EPA-700-8-87-037

GROUND WATER MONITORING EVALUATION  
HUGHES AIRCRAFT, U.S. AIR FORCE PLANT NO. 44  
TUCSON, ARIZONA

UPDATE OF THE HAZARDOUS WASTE GROUND WATER TASK FORCE EVALUATION  
OF HUGHES AIRCRAFT/U.S. AIR FORCE PLANT No. 44, TUCSON, ARIZONA

FIGURE 10 LOCATION MAP FOR NEUTRON LOGGING HOLES

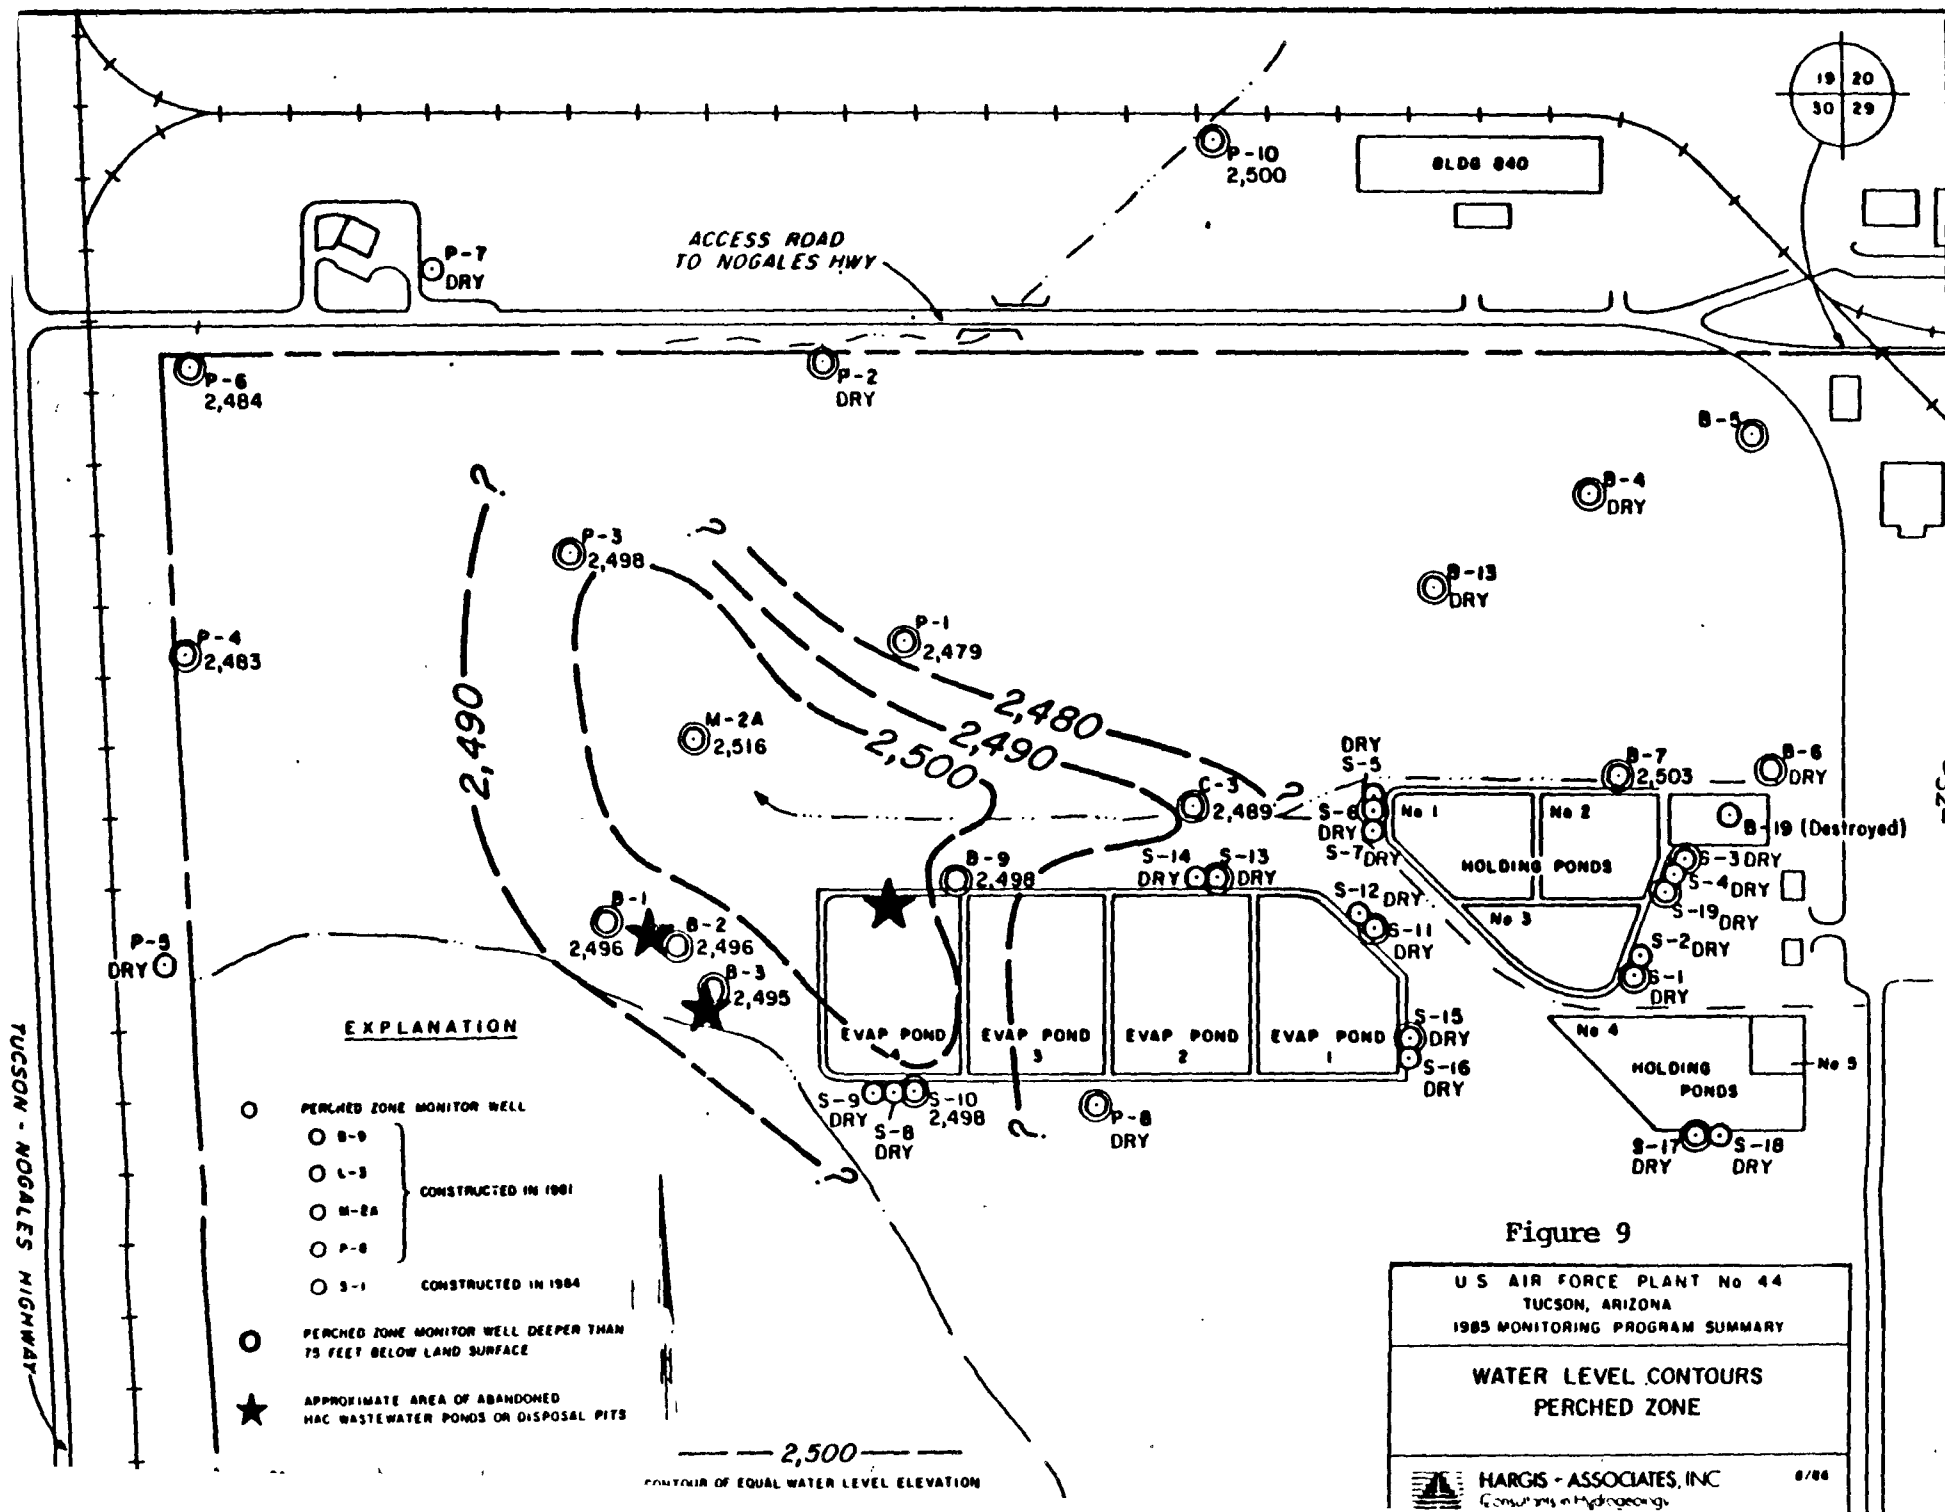
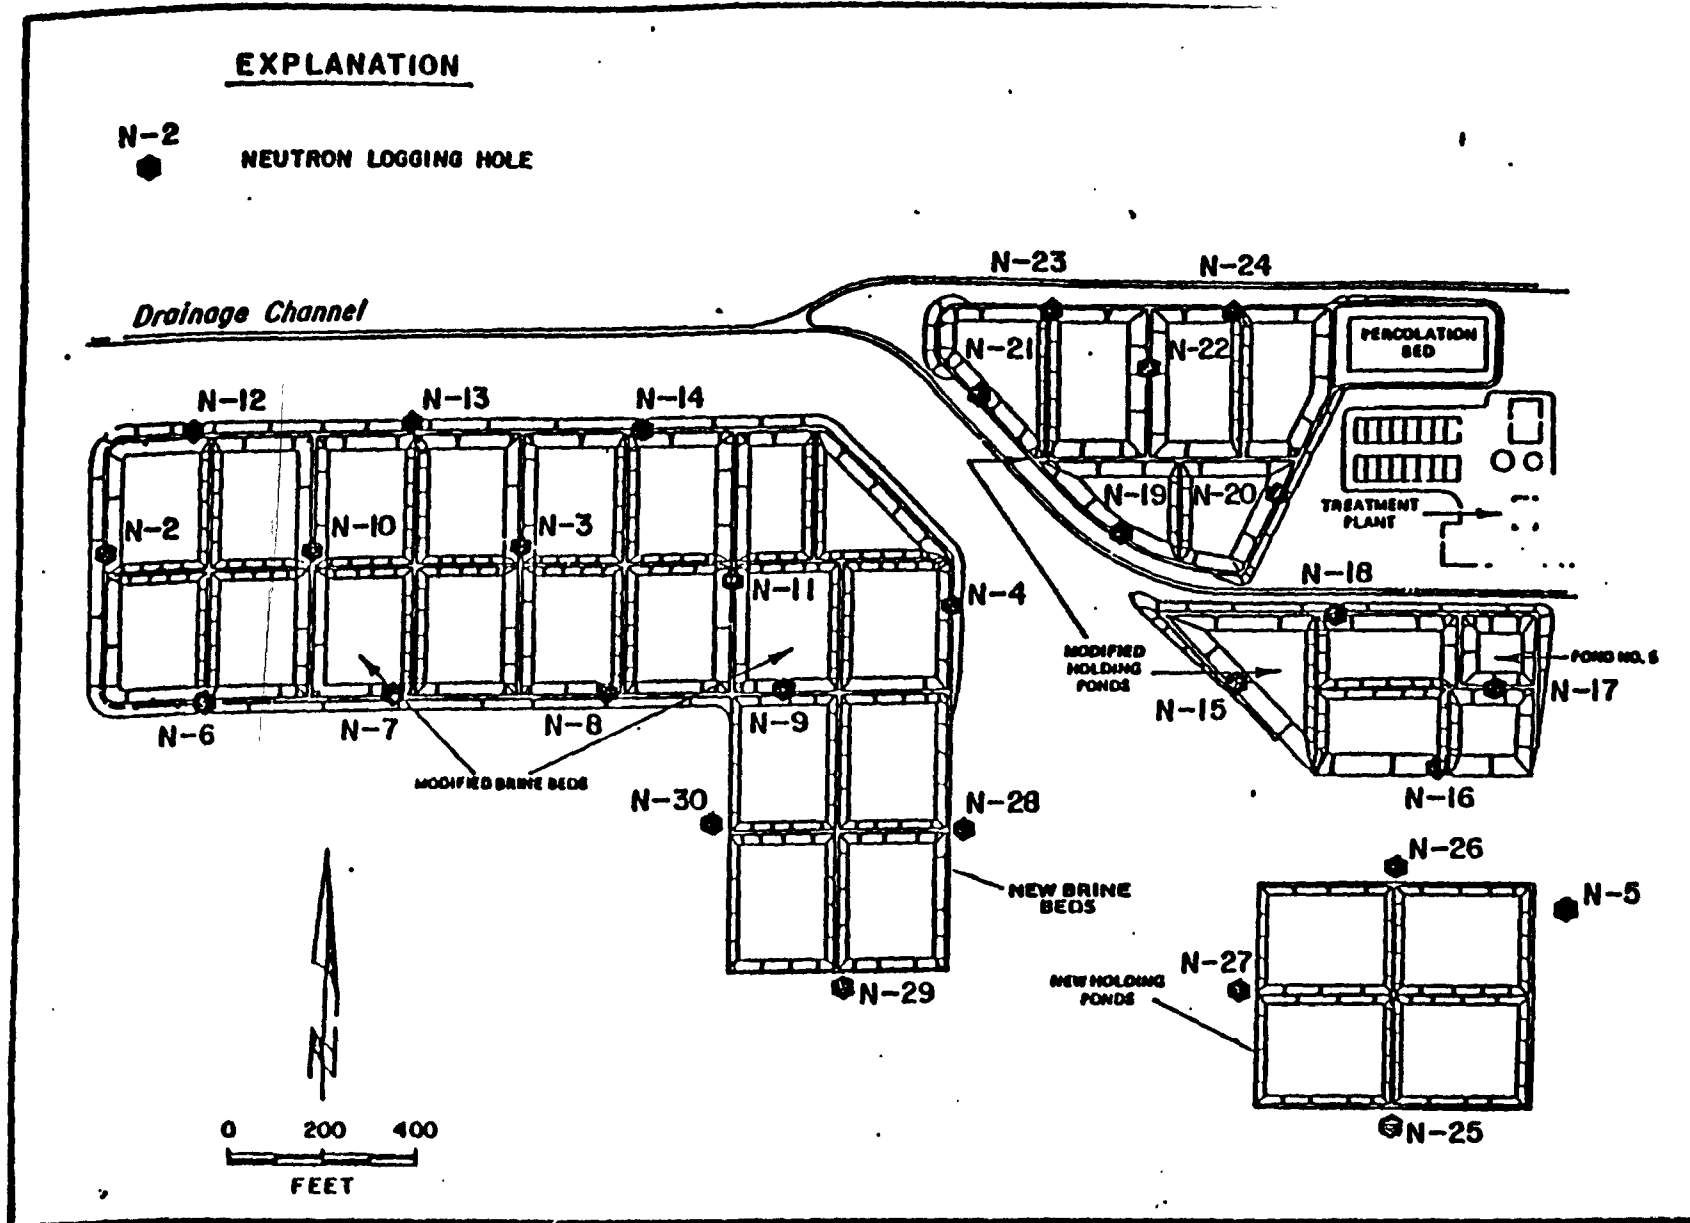
The present RCRA monitoring system consists of 26 perched zone wells (Figure 9) and 30 neutron probes (Figure 10). The FFCA requires the facility to sound perched zone wells B3, B6, B7, B9, B19, C3, P8, and all S-series wells monthly. Whenever a well shows a water level rise of over one foot, that well must be

FIGURE 11 SCHEMATIC DIAGRAM OF MONITOR WELLS  
CONSTRUCTED IN THE PERCHED ZONE (From Hargis, Phase II)

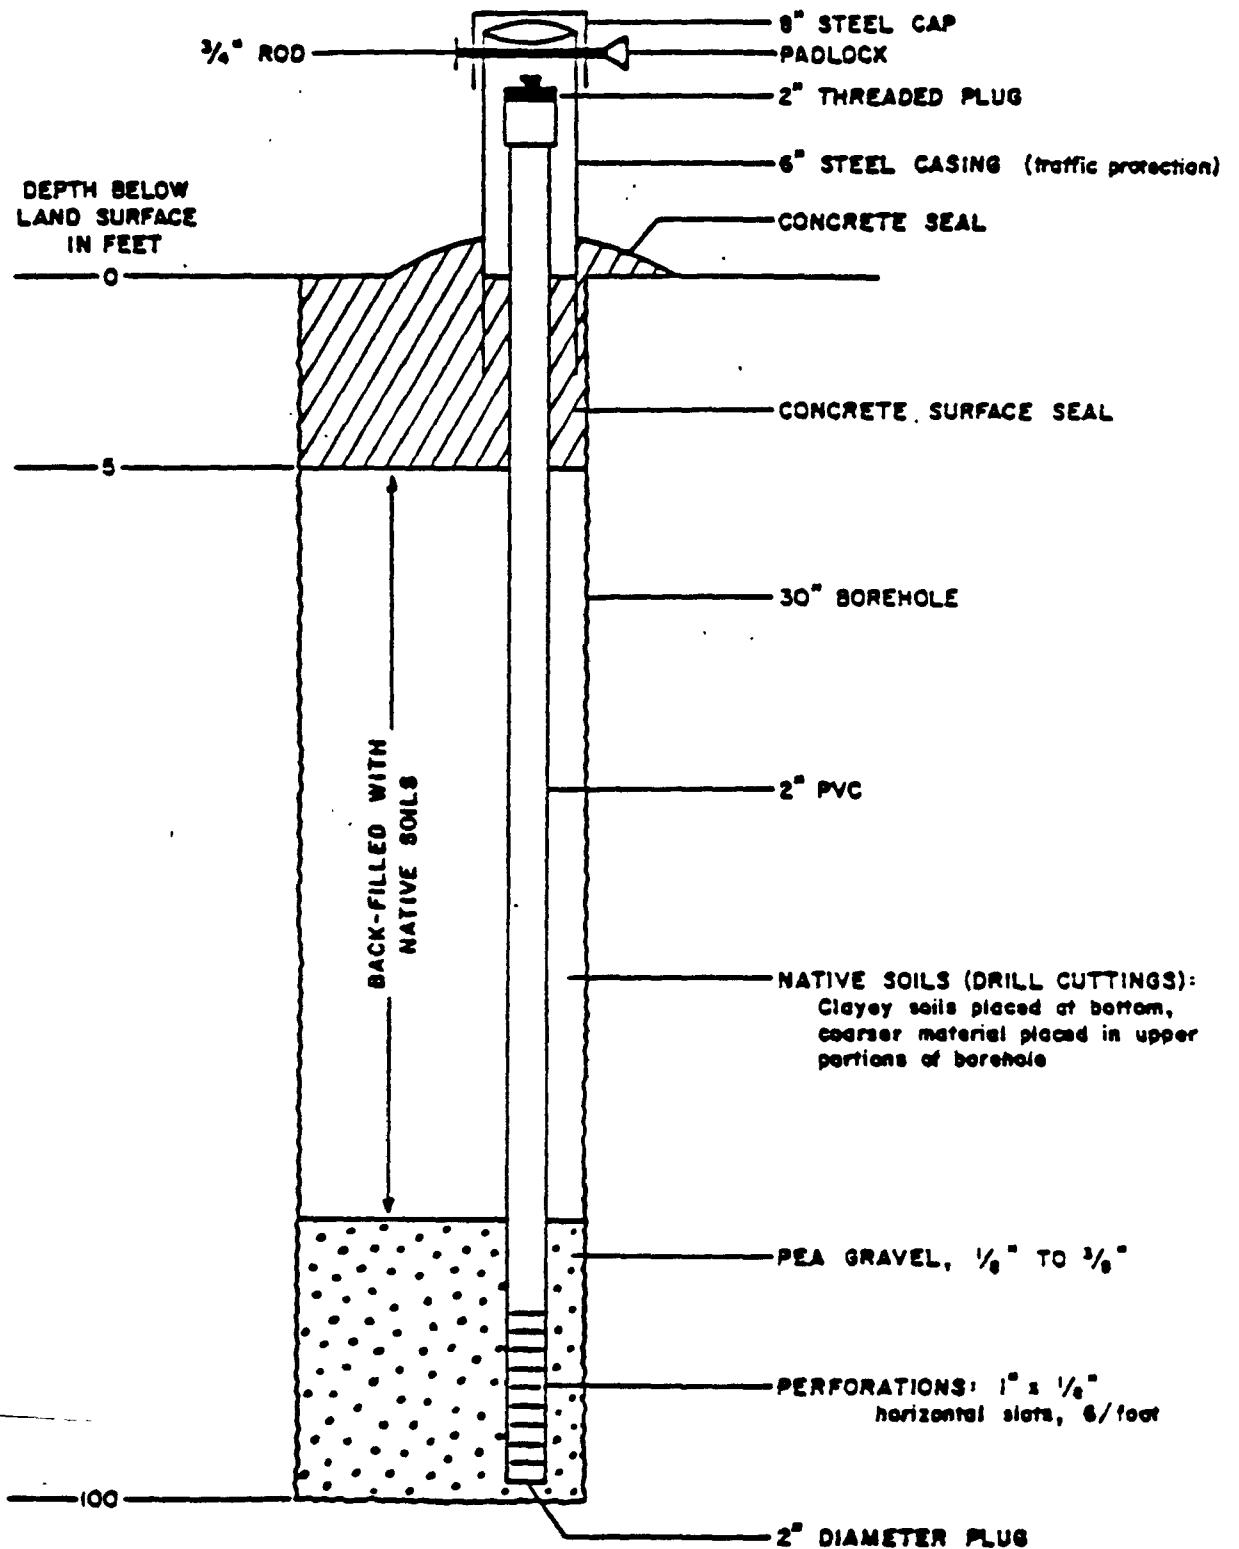
Perched zone wells generally consist of 2 or 3 inch PVC pipe, capped and slotted at the base with pea gravel filter pack, and cemented inside a 6 inch surface casing (see Figure 11). These wells do not meet current design or construction standards for RCRA monitoring wells. The wells contain excessive screen lengths, contain no annular seal, do not contain a filter pack matched to the aquifer material, and do not monitor the uppermost aquifer system as is required. The monitoring system is also not based on an adequate hydrogeologic site characterization plan.
